16 March 2022 (reissued 26 June 2022)

APPLICATION TO AMEND PERMIT PA1900745 – MOKOAN 2 SOLAR FARM

Figure 1 - Mokoan Solar Farm in relation to Benalla Yarrawonga Road (Source: Google Earth, 2022)

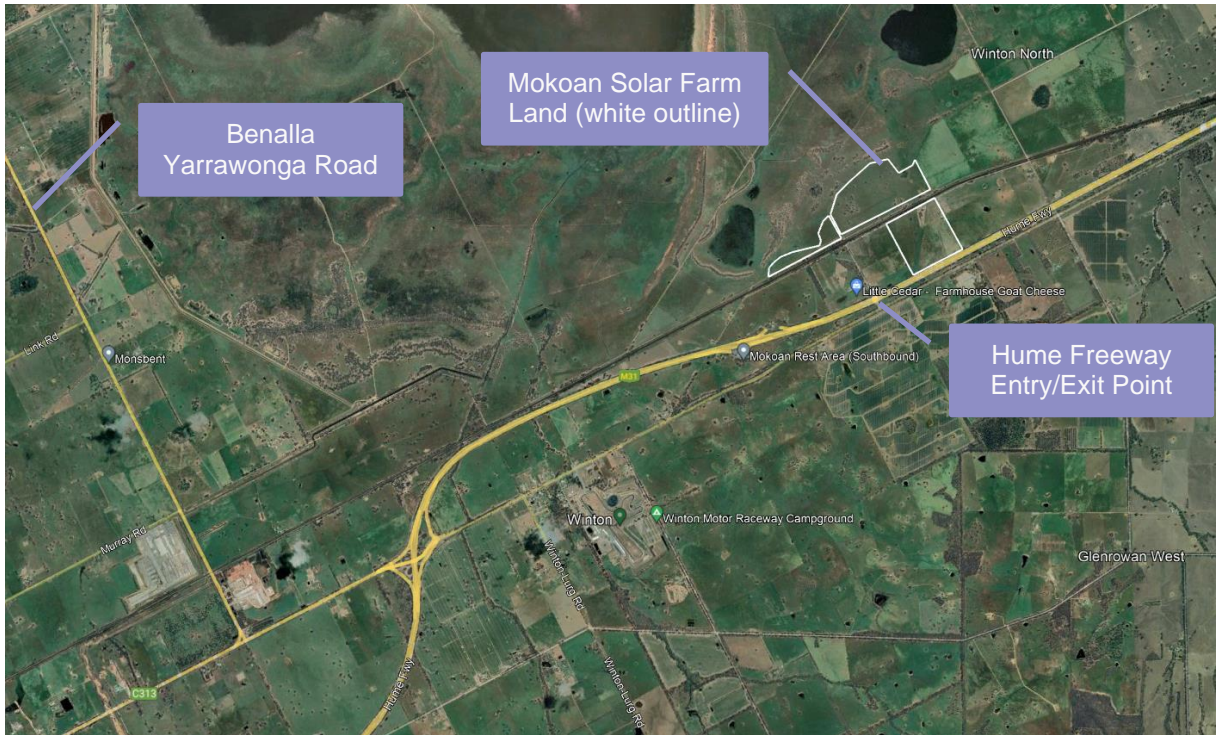
Benalla-Yarrawonga Road is not relevant to the site and should be removed from this list. It is 7km from the site and it will not form part of the access route.

In response to the above, we point out that Benalla Yarrowonga Road is not proposed to form part of the access route for the Mokoan Solar Farm (formerly referred to as Mokoan and Mokoan 2). Refer to Figure 2 which was prepared for Mokoan 2 and shows the route which will be used for both sites which comprise the Mokoan Solar Farm to connect to the Hume Highway.

Figure 2 - Site access route (Source: GTA Consultants, 2019)

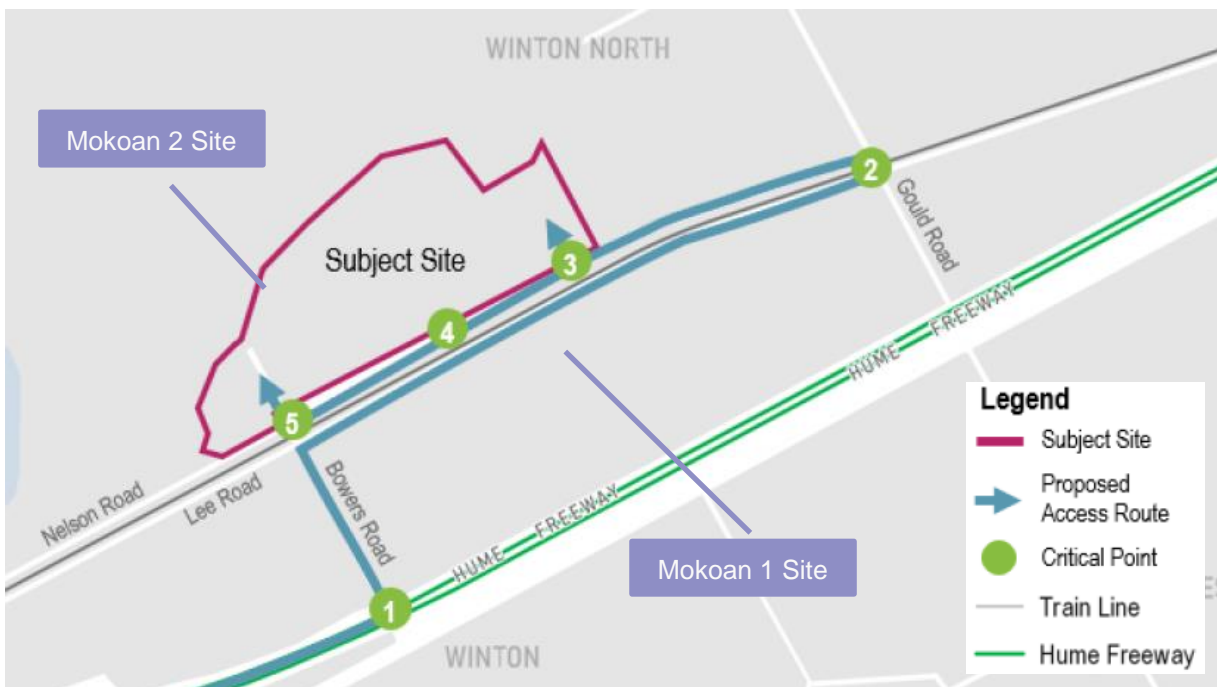
For clarity the details of critical points identified in Figure 2 are provided below.

- 1. The access arrangement consists of vehicles accessing Bowers Road. As noted in the Traffic Impact Assessment for the approved 116 Lee Road development [Mokoan 1], there is sufficient width in the freeway median to store a 19 metre semi-trailer without impact on through traffic. However, it is noted that a B-double cannot be accommodated within the existing median.*

- 2. A constrained traffic arrangement is currently in place at the Gould Road level crossing, with trucks accessing the site required to undertake two sharp turns and travel across a rail level crossing. Swept paths have been undertaken in Appendix A assessing the movement of a 19m semi-trailer and a B-Double, with annotations indicating road improvements required in order to complete the manoeuvre. It is recommended that a civil or geotechnical engineer be appointed to assess the ability for the railway crossing at Gould Road to support construction vehicles.*

- 3. The eastern access point to Nelson Road will need to be designed to fully accommodate the turning circle of the maintenance vehicles expected to access the site during operation. Swept paths have been undertaken in Appendix A which indicate the site is accessible for an 8.8m Medium Rigid Vehicle (MRV). An MRV is representative of the anticipated operational and maintenance vehicles required to access the site.*

- 4. The condition of Nelson Road is currently poor, with signage indicating it can only be used during dry weather. It is expected that articulated vehicles may have difficulty using the road even during dry conditions as it is currently unsurfaced. However, it is recommended that this is assessed and confirmed by a geotechnical engineer.*

- 5. The western access point to Nelson Road will need to be designed to fully accommodate the turning circle of the vehicles expected to access the site. Swept paths have been undertaken in Appendix A which indicate the site is accessible to an 8.8m MRV. An MRV is representative of the anticipated operational and maintenance vehicles required to access the site.*

Lightsource bp is seeking an amendment to the above condition through an application for a secondary consent and requests that the wording is amended to reflect the route shown in Figure 2 and excludes Benalla Yarrawonga Road.

the developer must upgrade the road, drainage and other civil work from the intersection of Nelson Road/Gould Road the westernmost subject site entrance along Nelson Road and to incorporate earthworks, all weather sealing, gravelled shoulder, drainage, line-marking and environmental treatments across the frontage of the development, and in accordance with plans and specifications approved by the responsible authority in accordance with the Infrastructure Design Manual. Specific details are as follows:

- a. All weather sealing (including turning lanes and passing lanes), gravelled shoulders, signage and vehicular crossings from Nelson/Gould Road intersection to the westernmost subject site entrance
- b. Passing lane at the entrance for the safe movement of heavy vehicles.
- c. Underground drainage.
- d. Appropriate signage, intersection and traffic (control/mitigation) measures.
- e. Stormwater retention and quality treatments.
- f. Road drainage.
